**ADVISORY COMMITTEE ON REACTOR SAFEGUARDS
REGULATORY POLICIES AND PRACTICES SUBCOMMITTEE
MEETING MINUTES
February 24, 2017
Rockville, MD**

The purpose of the meeting was to review Draft Final Regulatory Guide (RG) 4.25, “Assessment of Abnormal Radionuclide Discharges In Ground Water to the Unrestricted Area at Nuclear Power Plant Sites.”

Official Transcript of Proceedings, Regulatory Policies and Practices Subcommittee, Friday, February 24, 2017, Rockville, MD.

Draft Regulatory Guide 4.25
*Assessment of Abnormal Radionuclide Discharges
In Ground Water to the Unrestricted Area
at Nuclear Power Plant Sites*

Ranked list of radionuclides at commercial nuclear power plants based on their relative abundance, activity, and transport characteristics [Table 1 in ANSI/ANS 2.17]

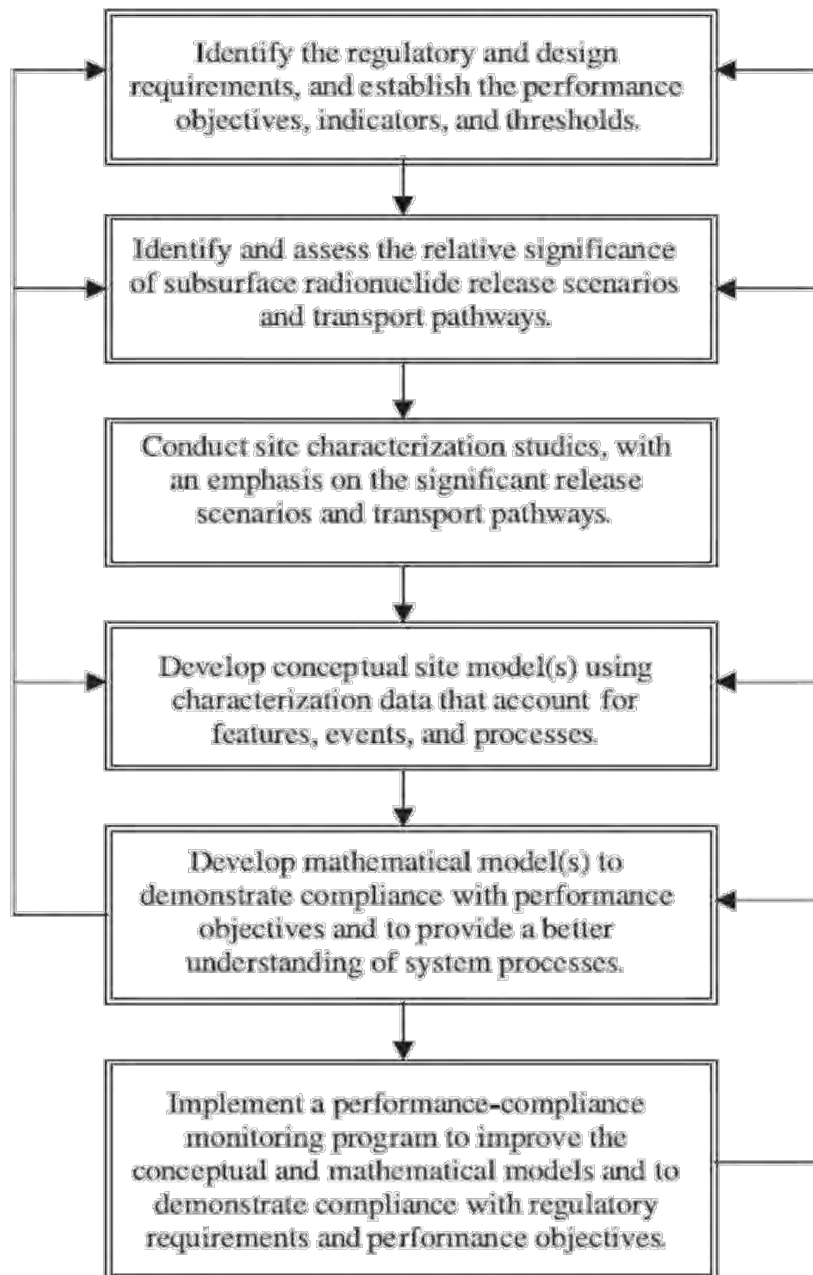
This is - this is too whiny almost for a comment. But since once of you was an author of the ANSI/ANS standard, the table Dana brought up isn't really well explained there.
